Engine Harness Relocation
D11 US2015
VAH, VHD, VN

SP 373-021, Engine Harness Relocation

(December 2015)

W3107068

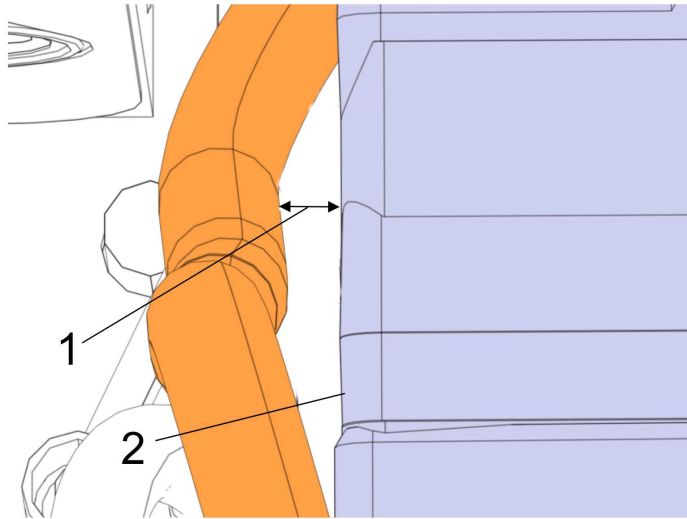
The engine harness on VOLVO D11 US2015 engines built between March 1, 2015 and August 31, 2015 may be making contact with the air compressor head and rubbing through. It will be necessary to relocate the harness in this area. If wire damage is noted during the harness relocation, reference FSB 373-022 for the repair instructions and continue with the harness relocation after the repairs are done.

- 6 Relocate the engine harness (2) and install double tie retainers (part number 20885496) as shown (A and B) to secure harness to cylinder head fuel line (3). Ensure harness is not touching air compressor. Make sure the ties are snugged tight.
